**TECHNICAL AUDIT REPORT OF ELECTRIC LOCO SHED MUGHALSARAI (ECR)
ON MAINTANCE OF BRAKE SYSTEM
FOR
CONVENTIONAL ELECTRIC LOCOMOTIVES**

Report No: RDSO / 2018 / EL / TAR / 0017, Rev. '0'

Technical Audit Report of ELS/MGS/ECR

Fig.1 Photos of overhauled components wrapped with poly bags to protects from moisture

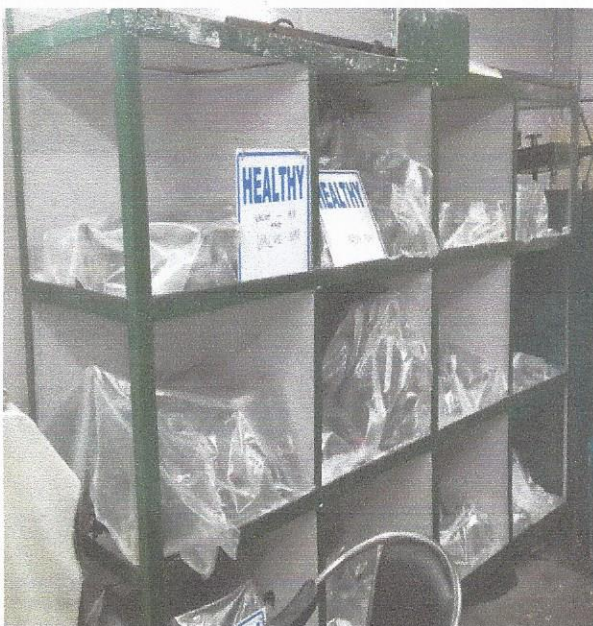
- 2.1 Overhauled components of IRAB are kept separately in a room nearby overhauling area and test benches.

- 2.2.1 Storage space is required to be improved to identify components of various equipment of IRAB which should be clearly segregated so that they can be picked up conveniently as per requirement.
- 2.2.2 Storage of rubber component in section should be in a dry and temperature controlled environment.
- 2.2.3 First In First out (FIFO) system should be followed to avoid prolonged storage of rubber components and use of rubber items will be within shelf-life period.
